20 October 2020

Subject: *Objection to the Extension of CDP-#A-6-ENC-18-0019 (Leucadia Streetscape) Coastal Development Permit*

Figure 1: Leucadia Floodplain Map. Representative flood extent depicted here to display to approximate domain of typical flooding.

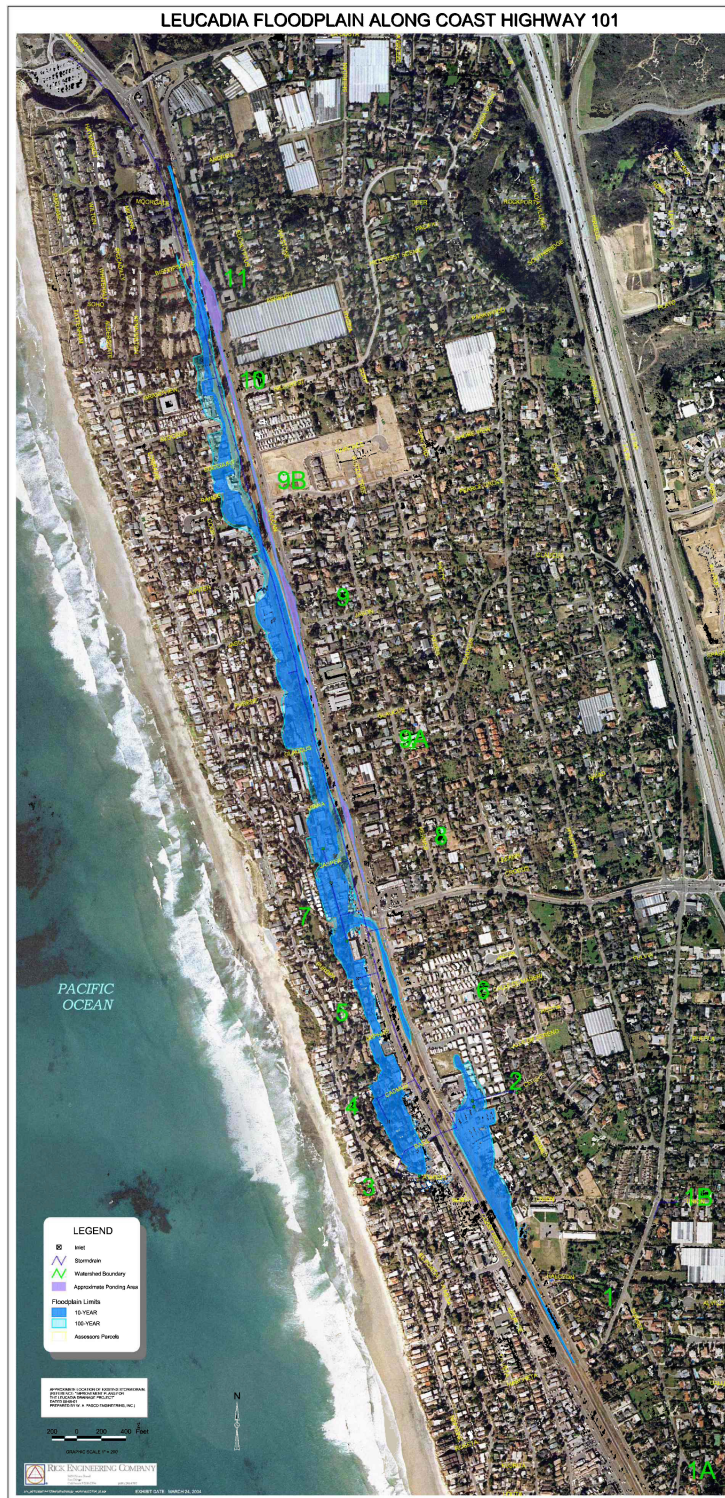
Streetscape is located directly in a flood zone that floods regularly as shown in Figures 1, 2, and 3. The hydrology section of the Streetscape EIR documents, as part of the basis for the original CDP, the construction of stormwater retention areas within parking areas alongside the railroad to facilitate the dispersion of stormwater into groundwater. This groundwater flows to the ocean bluffs (Figure 4) where it contributes to both upper and lower bluff erosion and failures (Figures 5, 6). Some of these failures have killed people ([Coast News 2014](#), [Coast News 2020](#), [Newsbreak](#)).

Figure 3: History of precipitation in Leucadia. These data indicate a much higher frequency of flooding events than reportedly being addressed by the City of Encinitas’s contractors.

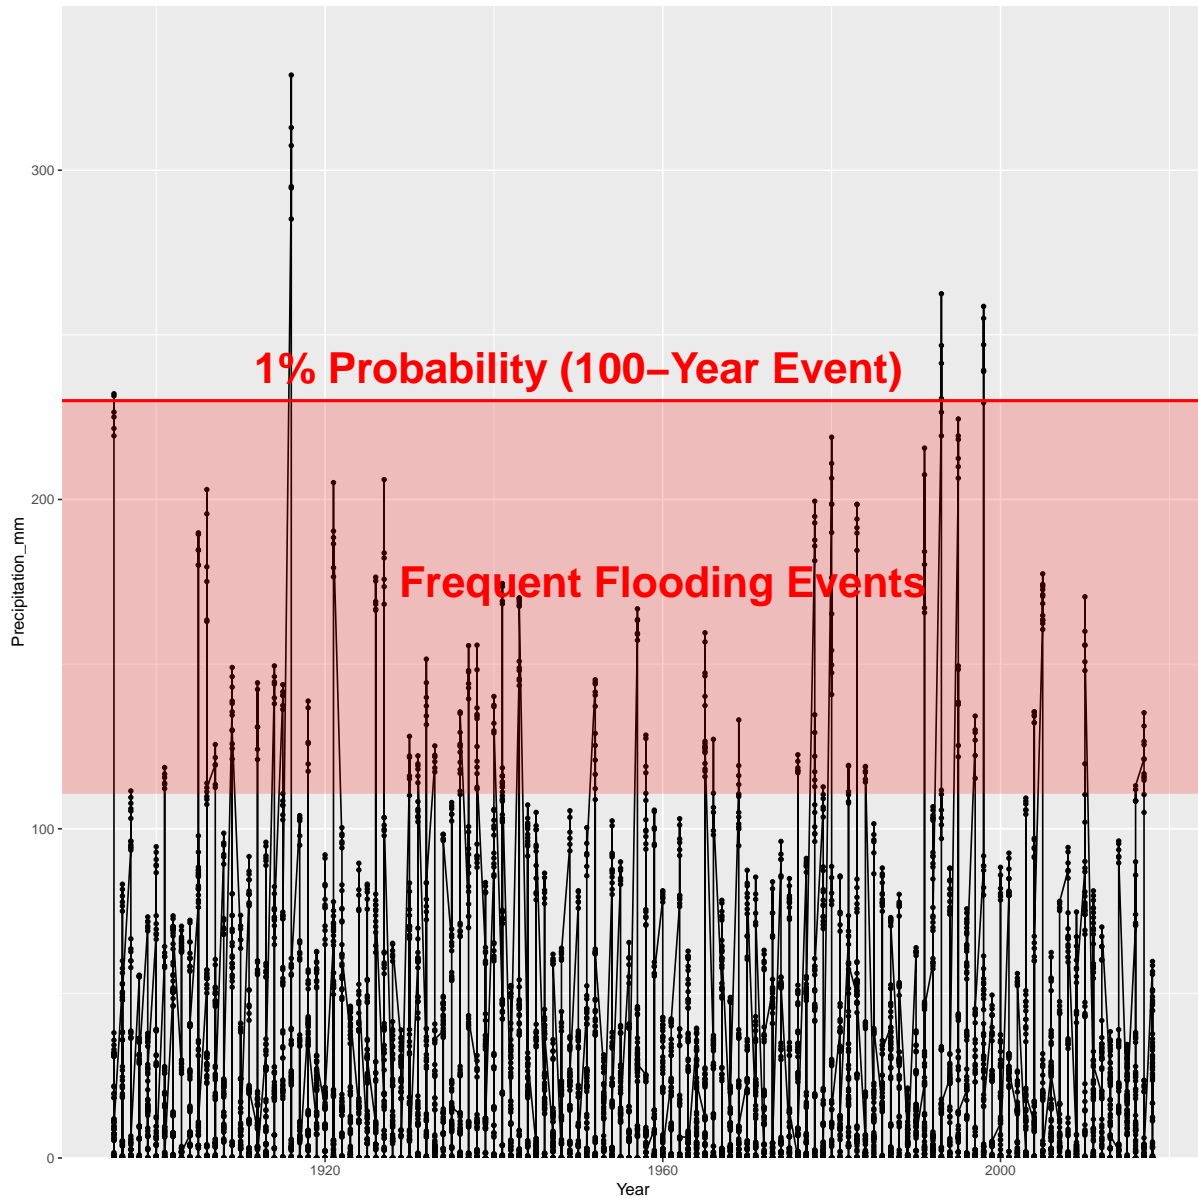
4. The historical rainfall for Leucadia, Figure 3, can be seen to be more complicated and important to consider in any rational design process and not done in some slap-dash fashion to satisfy the whims of a pet project of the current council and mayor.

Figure 8: Modifications being made to the Batiquitos Lagoon stormwater dumping to integrate a 60-inch stormwater pipe using a design that has not yet been publicly revealed or reviewed. Yellow lines indicate new construction plans based on data from the City of Encinitas.

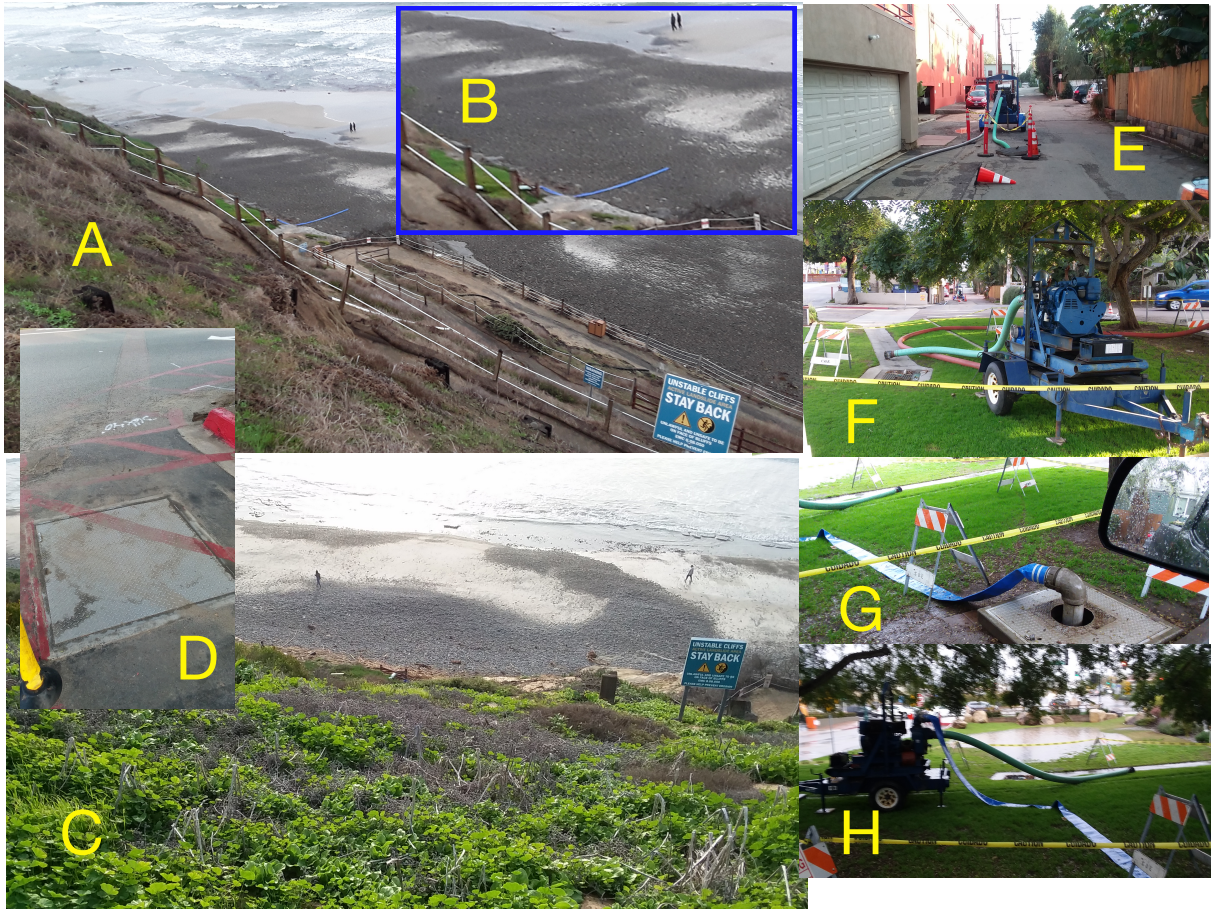
5. The COE made non-public changes to the stormsewer outfall in Batiquitos Lagoon under the cover of the Ponto hotel development (Figure 8). This work was interrupted by the RWQCB for failure to adhere to construction BMPs. The current outfall (Figure 11) may already be in violation of the Army Corps of Engineers criteria for navigable waters given the tidal flushing of the outfall stream.
